Project: C725 – HTR – Bedhampton to reservoir pipeline

Document Number: HTR-WAB-PI-P2-TN-W-0002_P2 Alignment S4. P03 - Hooks Farm Way Playing Fields

Document Title: P2 Alignment

Figure 2 Revised P2 alignment

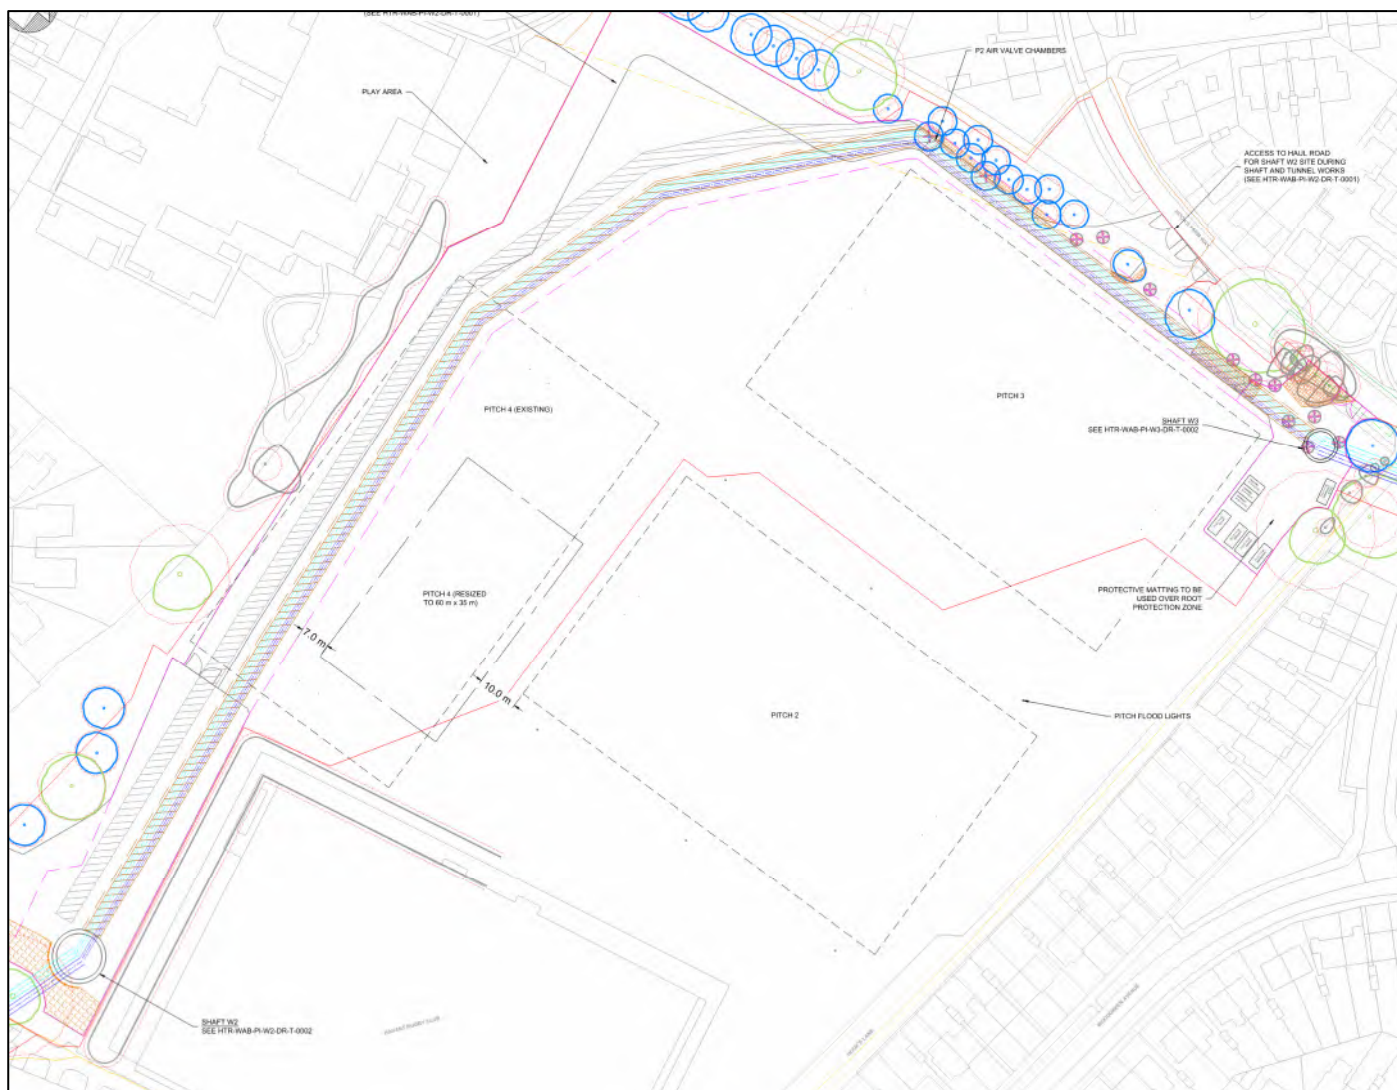
Following further post-submission engagement with St Thomas More’s School (see below), it is proposed to move the section of pipeline along the western boundary of the playing fields to the east, further away from the school, to allow the haul road to be used during the pipeline construction. This change will allow the pipeline installation adjacent to the school to be undertaken during the school summer holidays/rugby playing off-season whilst allowing other works at shaft 2 to continue. The haul road will run between the red line boundary and open-cut works, with noise barriers and hoarding parallel to the school boundary and next to noise producing equipment where possible. This is shown in **Figure 2** (refer to Appendix E for the associated drawing) below and informs a revised drawing for this section of the pipeline.

The site hoardings are shown by the solid pink line on the western boundary. The haul road (labelled) follows this boundary. The boundary during open cut works is shown by the dashed pink line to the East of the pipelines. Shaft W2 and W3 site compounds are also shown. See also the appended full-sized drawings.

Figure 3 Revised shaft W3 location

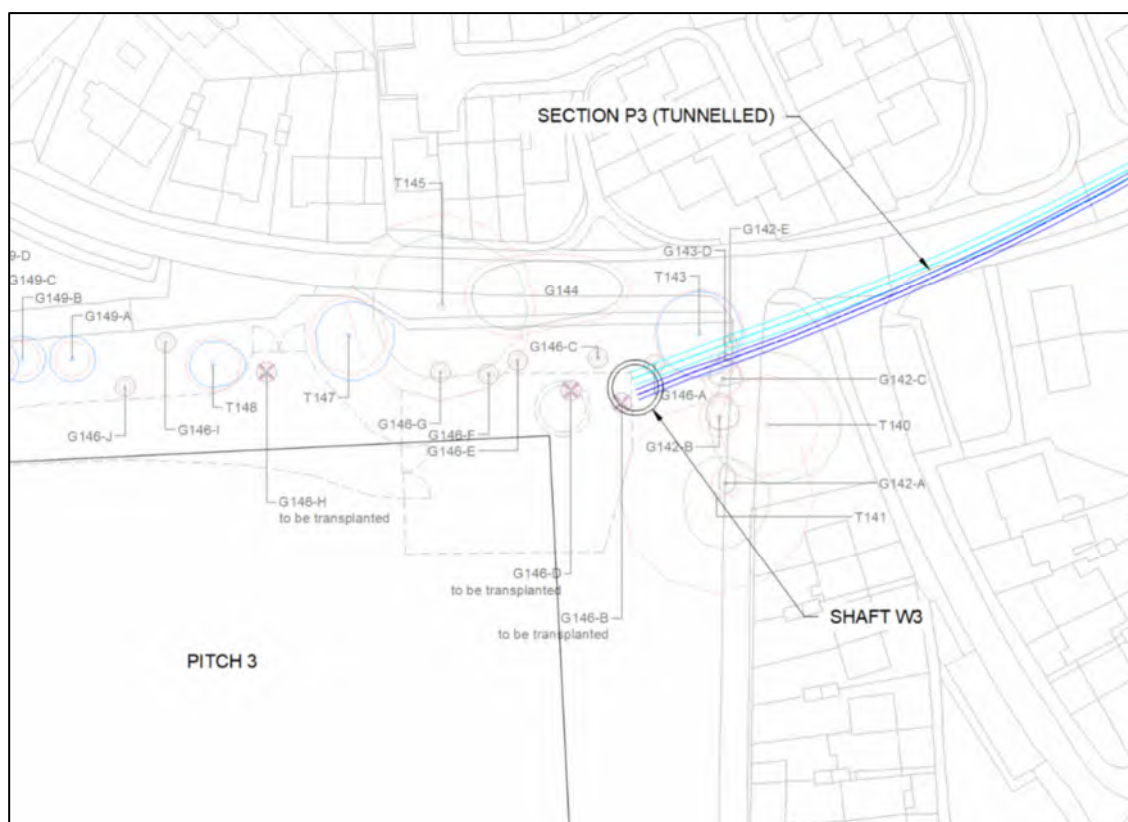
The location of Shaft 3 location (W3) was moved 11.5 m further east, as shown in Figure 3, and as indicated in the drawings submitted for planning. This movement places the shaft wall 10.7 m from the Dead-ball line of Pitch 3

(compared to 0.4 m in previous proposed position) and therefore allows the pitch to be used whilst the shaft is in its temporary condition (with a 3m run-off to the construction perimeter fencing). This was not possible with the original proposal *shown during the pre-application consultation* as the shaft was too close to the dead ball line.
